5. Design changes, EIS clarifications and additional information

5.1 Design changes

NORTHERN SYDNEY FREIGHT CORRIDOR

EPPING TO THORNLEIGH

Sheet 7 of 9

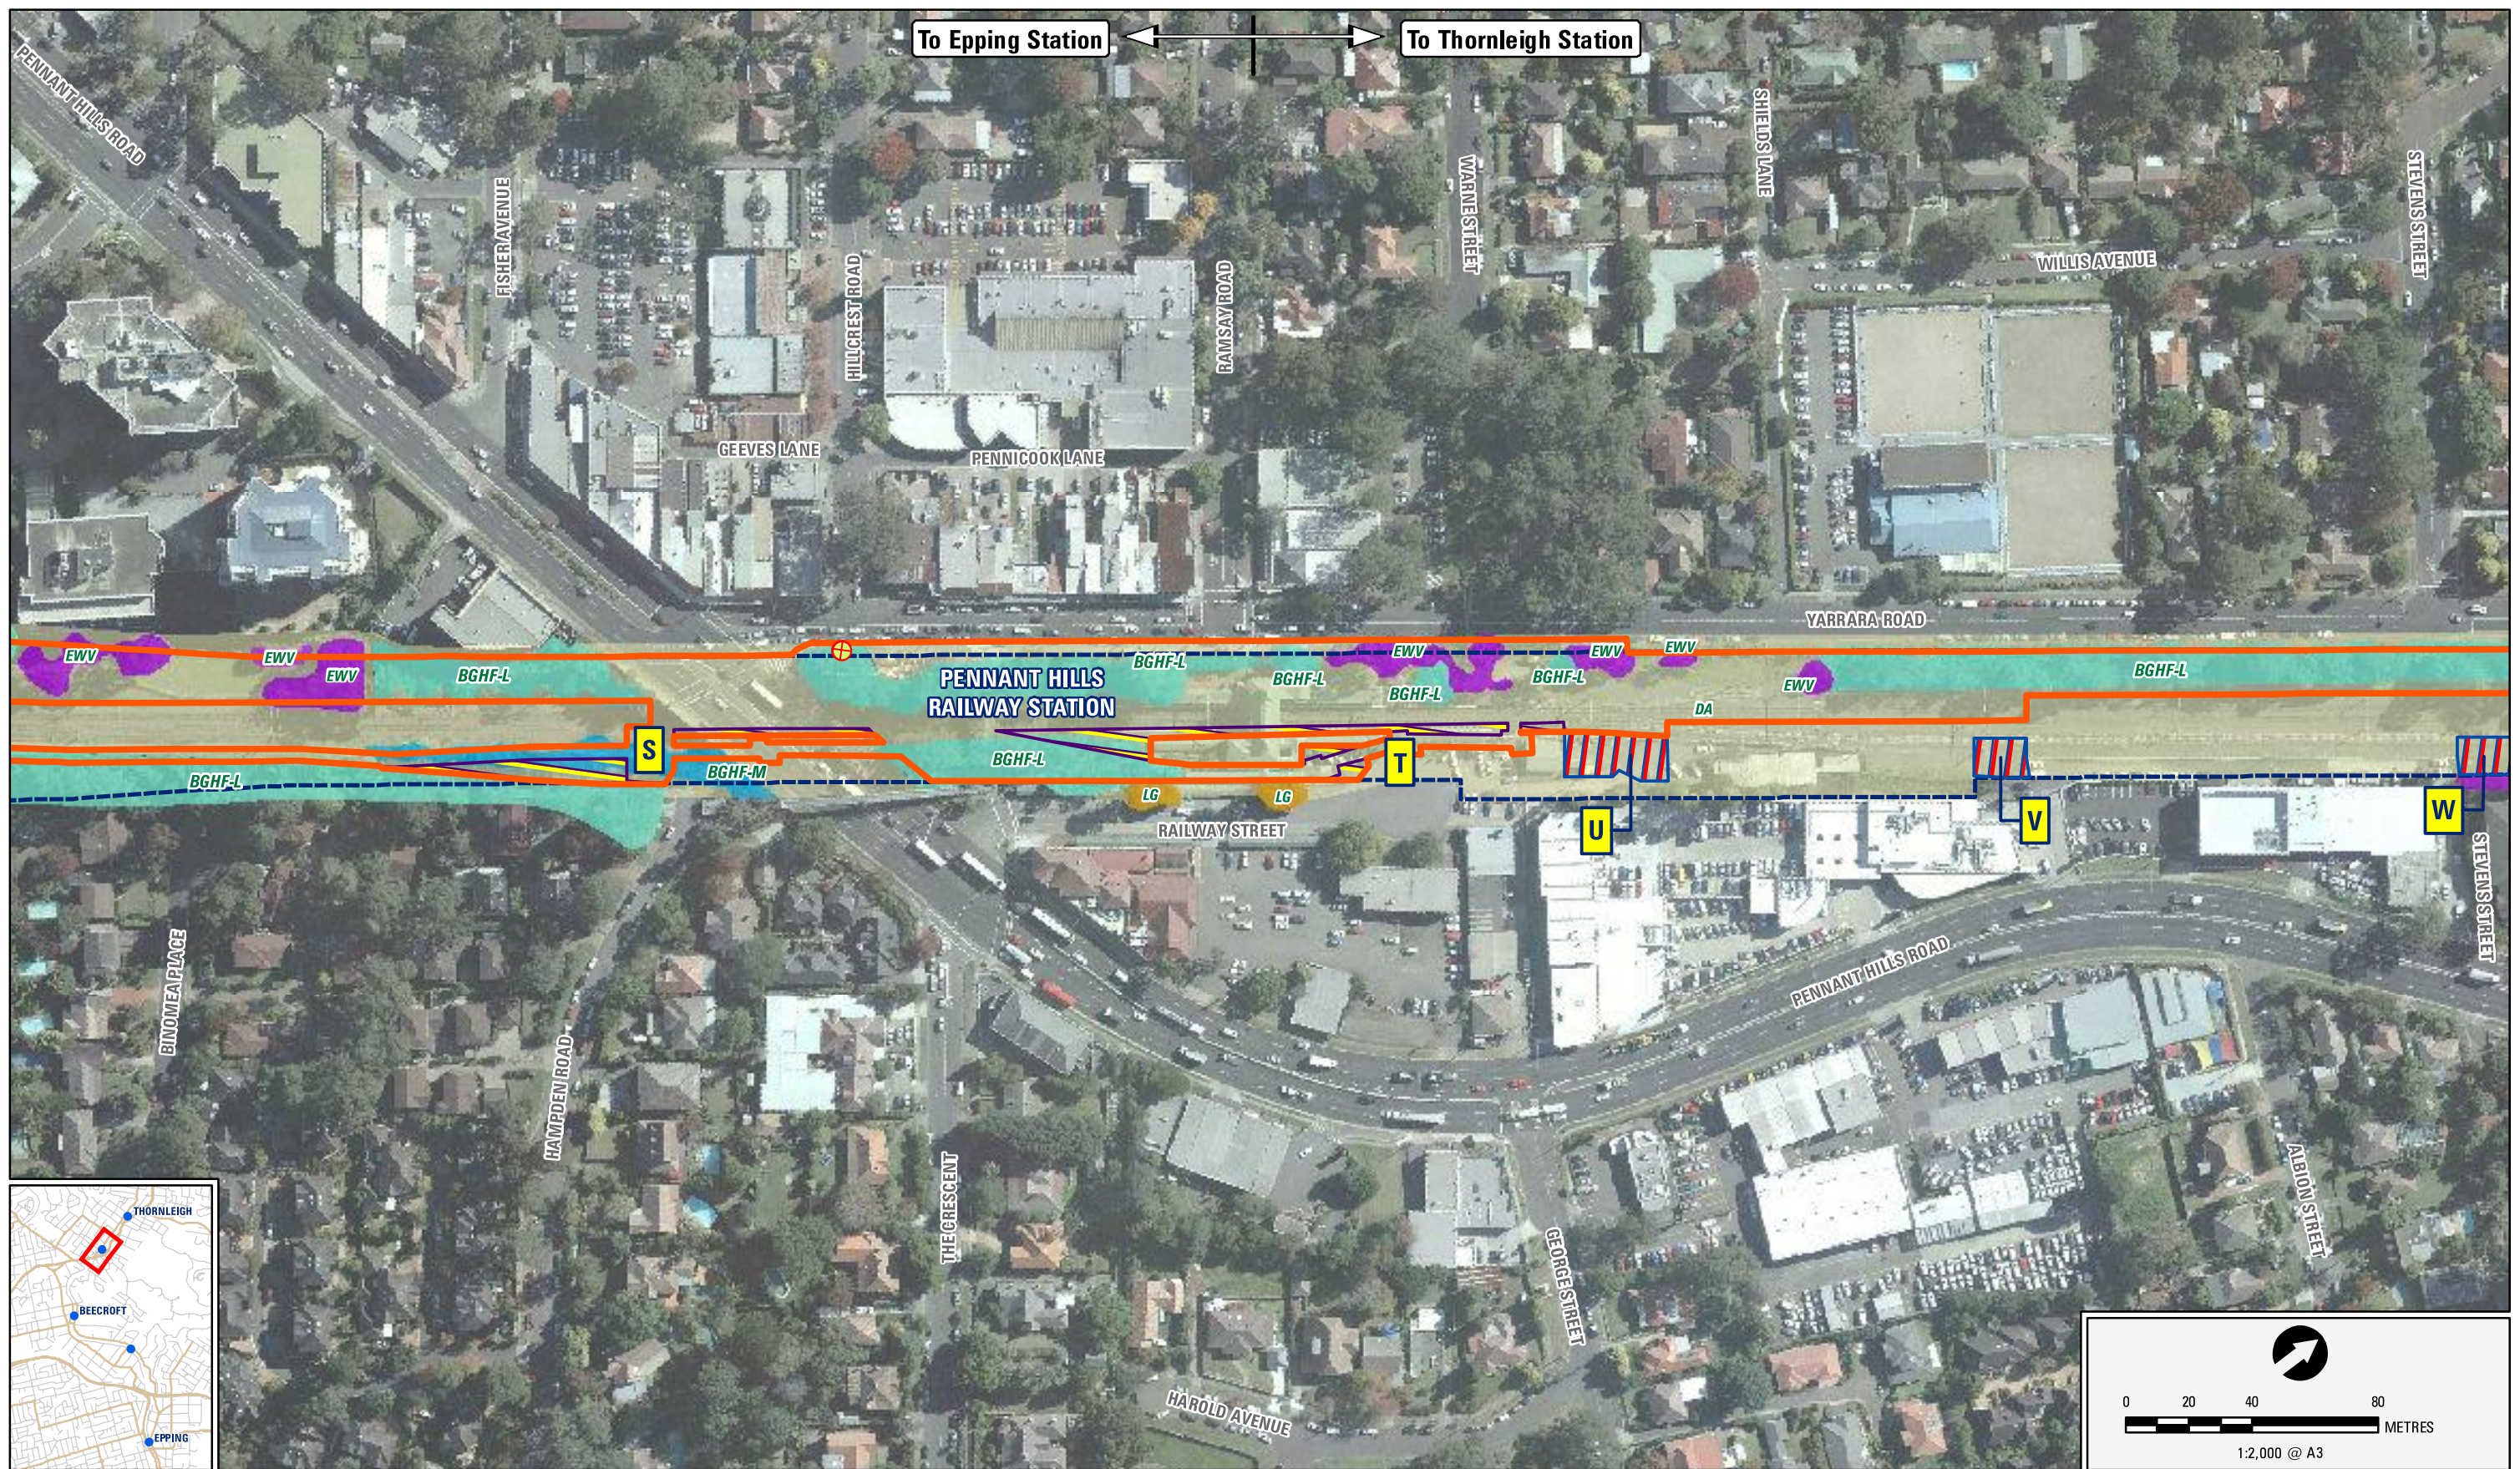
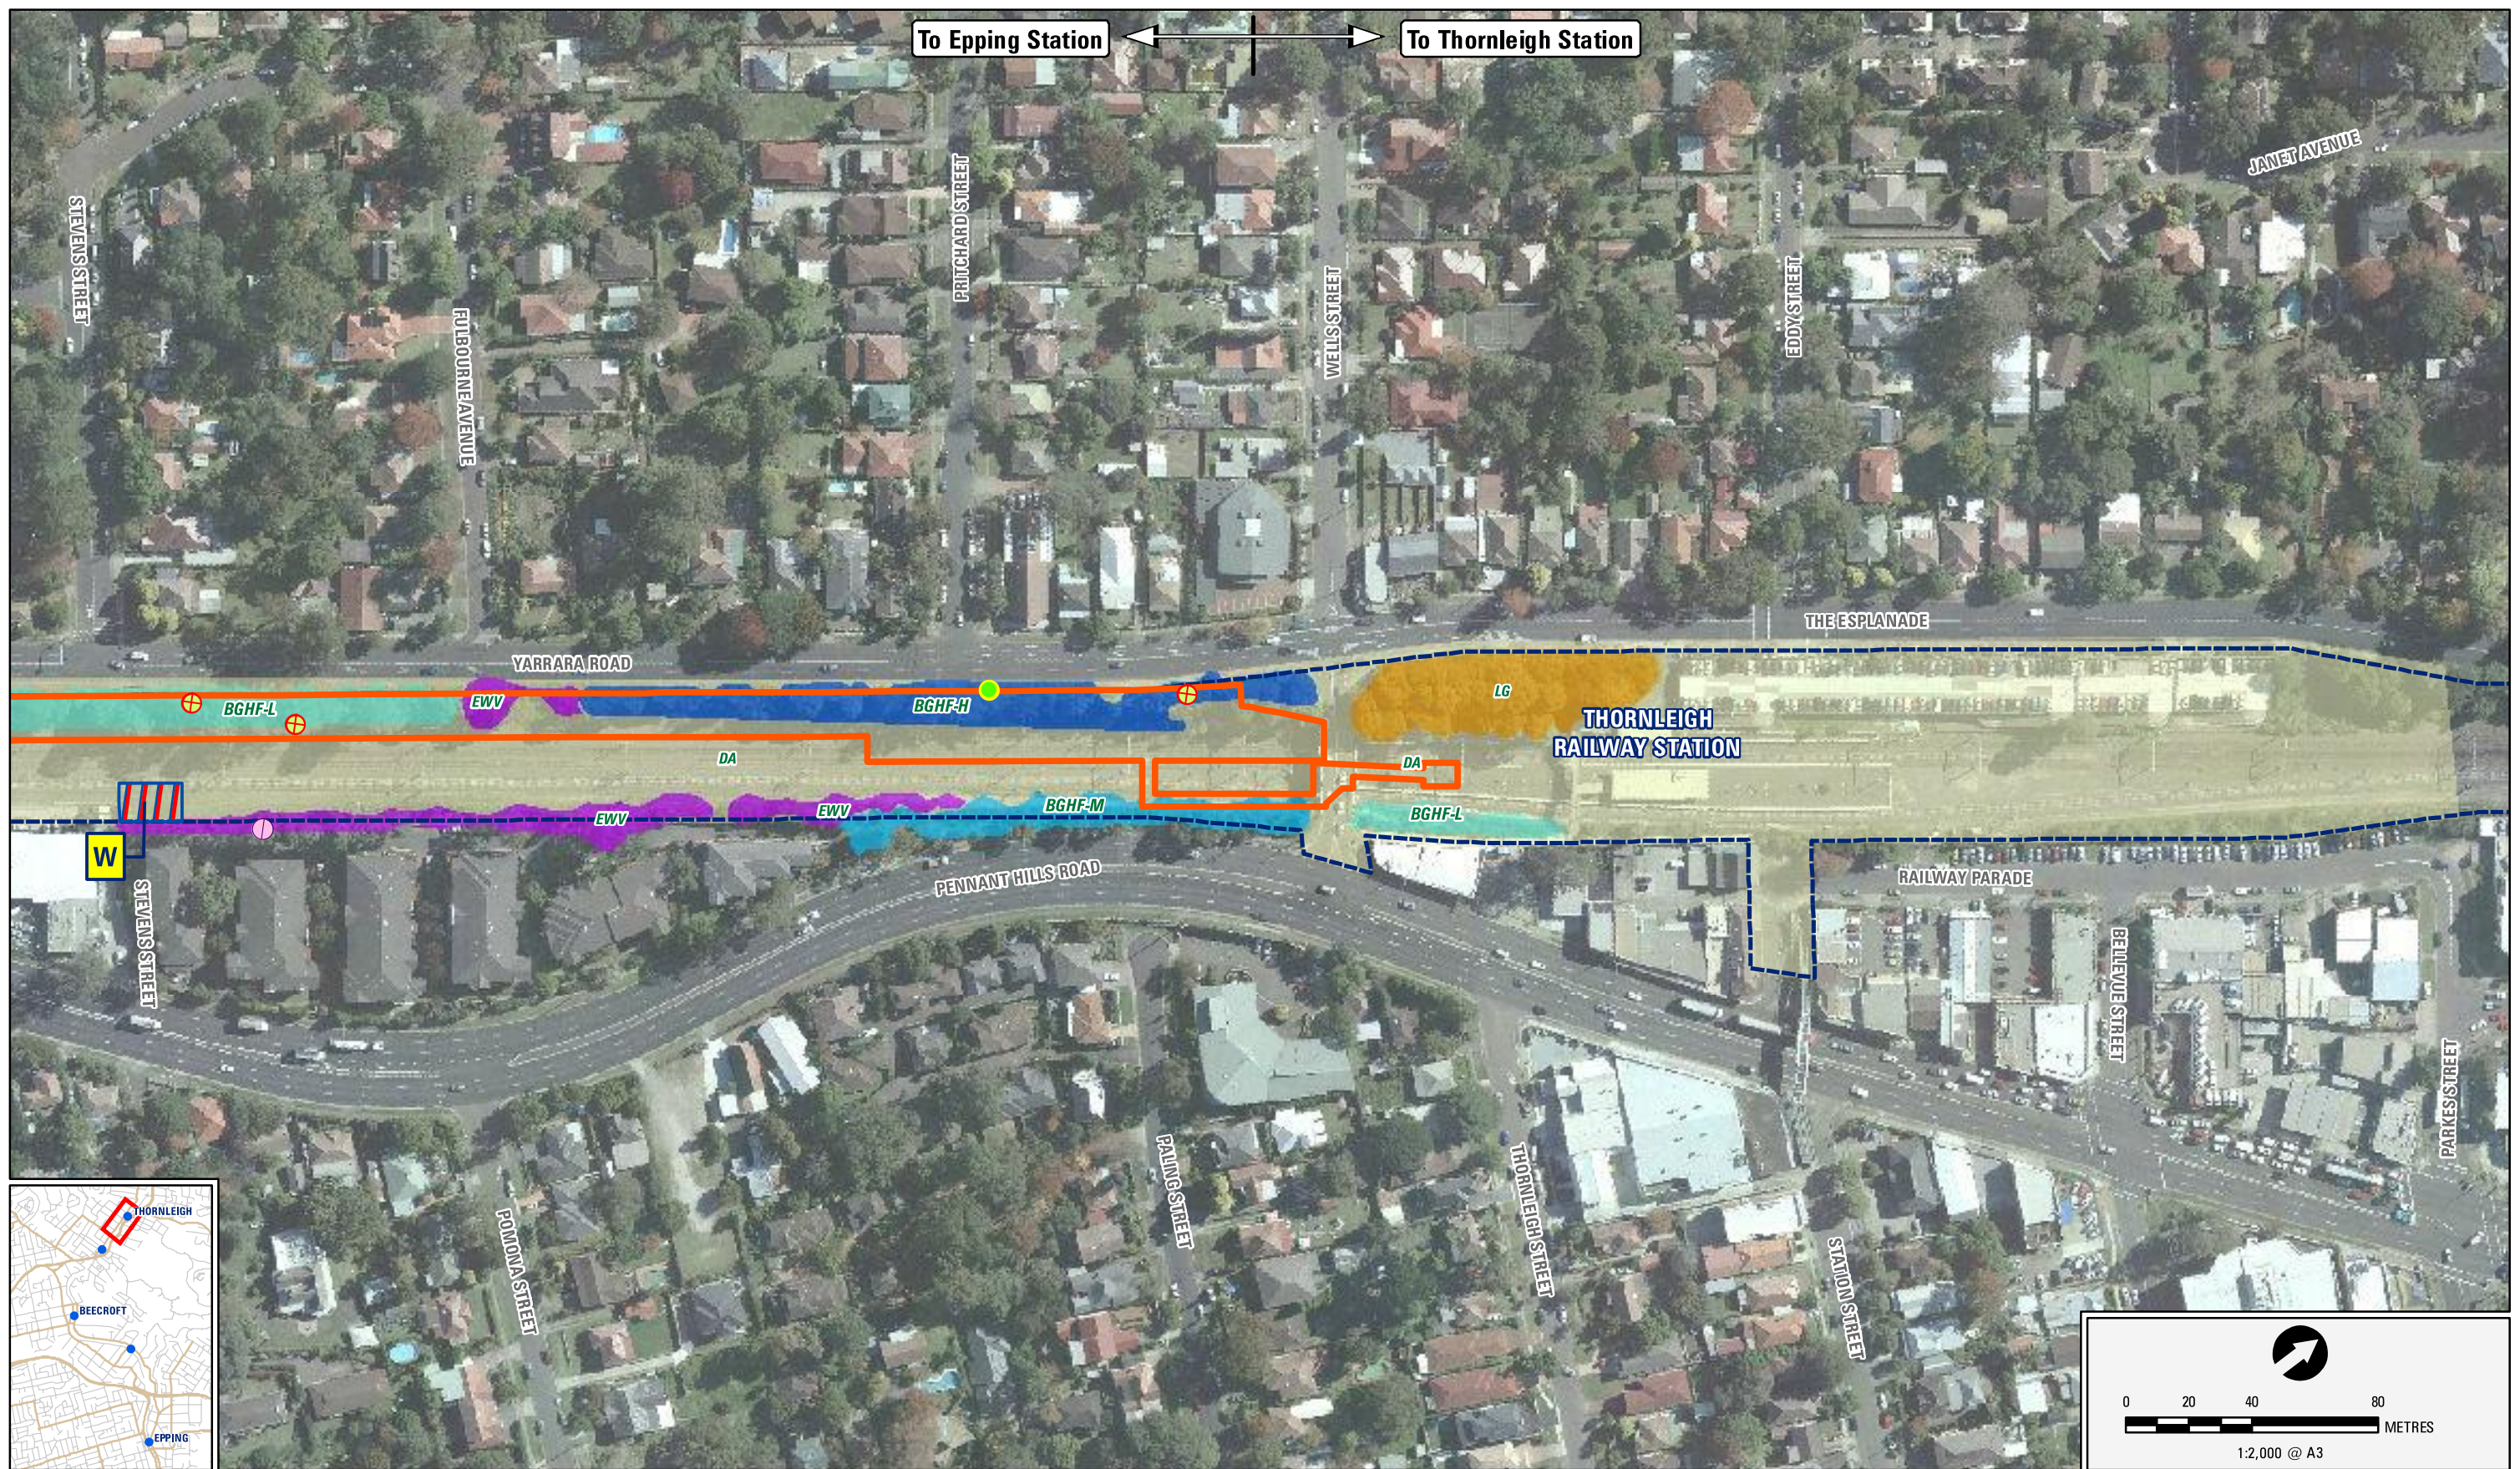
The construction impact area for the ETTT proposal, as shown in Figure 5.2 of the EIS, has been amended in various locations based on a review of constructability requirements. An outline of the proposed changes in construction impact area is provided in Table 5.1. A summary of the potential change in impact of the ETTT proposal as a result of each change is also provided in Table 5.1. The revised construction impact area for the ETTT proposal is shown in Figure 5.1.

Changed impact area	Description of proposed change	Summary of potential impacts
A	General work area increase to allow for the connection of the proposed railway services to existing facilities.	Increase in vegetation clearing and associated visual amenity impacts.
B1 and B2	Work area increased (onto Government owned land) to provide sufficient space for construction works, including the construction of the proposed viaduct and rail bridge crossing over the M2 Motorway and the delivery/storage of construction materials.	Increase in vegetation clearing and associated visual amenity impacts. Potential minor impact to heritage listed 'Bushland – Road reserve (between Carlingford Rd and Kandy Avenue)' (Hornsby LEP I 357) as a result of B1. Potential impact to the convict-built stone causeway crossing Devlins Creek (listed on Hornsby LEP) as a result of B2.
C1 and C2	General work area increase to provide additional area for access and construction of the proposed rail bridge crossing over the M2 Motorway.	Increase in vegetation clearing and associated visual amenity impacts. Potential impact to the convict-built stone causeway crossing Devlins Creek (listed on Hornsby LEP) as a result of C1.

D	Increase in trenching or installation of galvanised steel troughing for the connection of railway services between areas north and south of the M2 Motorway.	Increase in vegetation clearing and associated visual amenity impacts.

Changed impact area	Description of proposed change	Summary of potential impacts
E	Widened impact area to facilitate the establishment of a general work area. Area required for additional laydown, materials storage, construction of cuttings, establishment of a haul road for the removal of spoil, as well as to provide access for launching the structure of the proposed rail bridge crossing over the M2 Motorway.	Increase in vegetation clearing and associated visual amenity impacts. Area located adjacent to 'Ashby', a heritage listed house at 94 The Crescent, Cheltenham (Hornsby LEP I 297). Potential reduction in screening vegetation along the road reserve.
F	Modification to the combined services route (CSR).	Increase in vegetation clearing.
G1 and G2	General works area increase for a new power room, radio antenna and equipment room, and backup power supply.	Increase in vegetation clearing and associated visual amenity impacts.

H	Impact area widened to property boundary.	Nil.
I	General works area increase to facilitate construction of a new railway services pit and connection with public utilities/services.	Increase in vegetation clearing and associated visual amenity impacts.
J	Reduction in impact area due to the review of constructability requirements.	Reduction in vegetation clearing and associated visual amenity impacts.
K	Reduction in impact area due to the reduced clearance required at construction access gates.	Reduction in vegetation clearing and associated visual amenity impacts.
L	Reduction in impact area due to the reduced clearance required at construction access gates.	Reduction in vegetation clearing and associated visual amenity impacts.
M	General works area increase to facilitate construction of a new railway services pit and connection with public utilities/services.	Increase in vegetation clearing and associated visual amenity impacts.

O	Reduced area to reduce impacts on Beecroft Station Gardens and playground.	Reduction in vegetation clearing and associated visual amenity impacts.
P	Optimised car parking area to reduce impact area without reducing the number of car parking spaces to be provided.	Reduction in vegetation clearing and associated visual amenity impacts.
N	General works area increase to facilitate construction of a new railway services pit and connection with utilities.	Increase in vegetation clearing and associated visual amenity impacts.
Q	Increased construction impact area for the establishment of the combined services route and pits. Increase in trenching for services to facilitate construction of new pits and connections to railway services.	Increase in vegetation clearing and associated visual amenity impacts. However, impacts would be mostly confined to existing access roads within the rail corridor.
R	Increase in construction impact area due to a refinement of the new high voltage cable route	Increase in vegetation clearing and associated visual amenity impacts.

S	General works area increase to facilitate construction of additional services as well as facilitating construction access from Hampden Road, if required.	Increase in vegetation clearing and associated visual amenity impacts. However, impacts would be mostly confined to existing access roads within the rail corridor.
T	General works area increase for the installation of additional railway services.	Increase in vegetation clearing and visual amenity impacts
U, V and W	Reduction in impact area due to the reduced clearance required at construction access gates.	Reduction in vegetation clearing and associated visual amenity impacts.

Figure 5.3 Alternative access options available during the closure of the Chapman Avenue overbridge

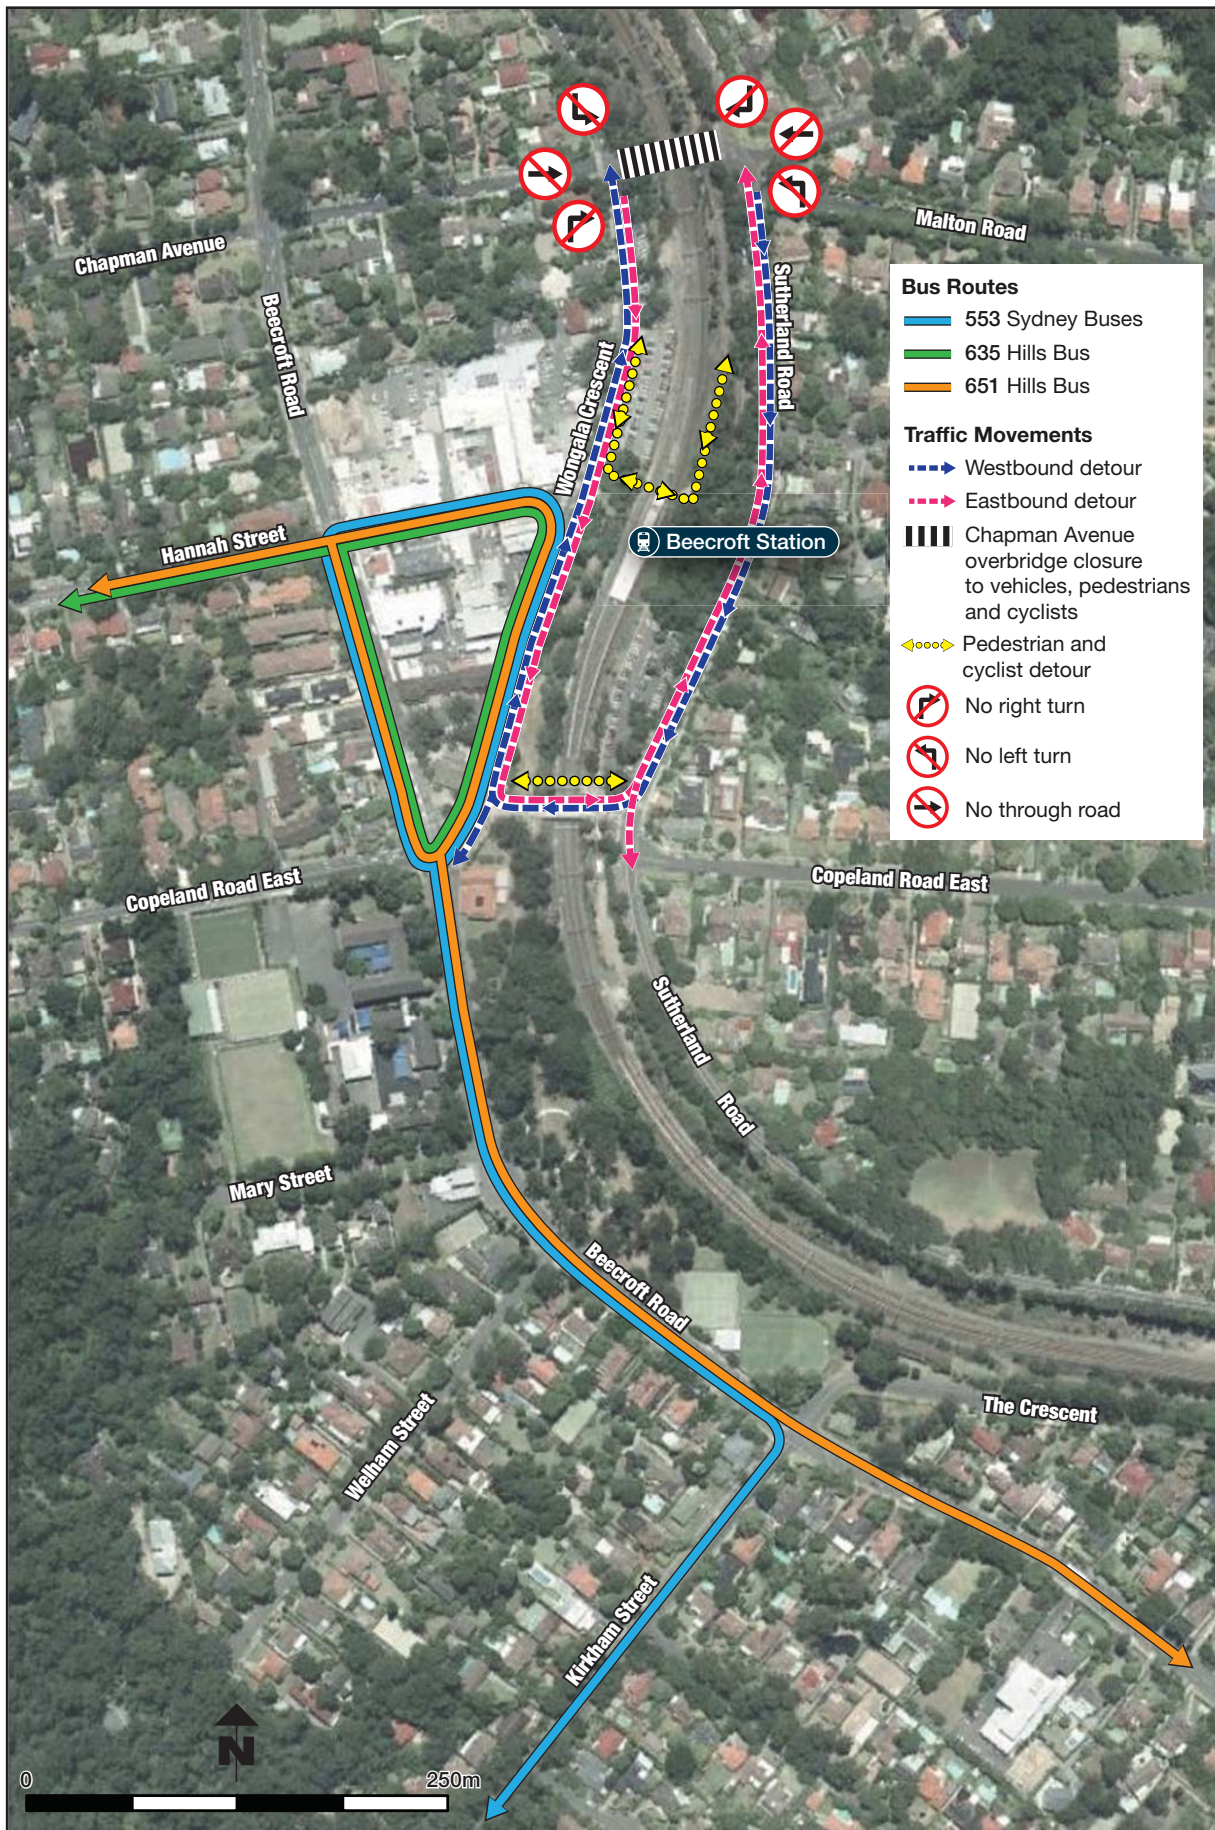
Alternative access routes that would be available for vehicles, buses, pedestrians and cyclists during the closure of the Chapman Avenue overbridge are shown in Figure 5.3.
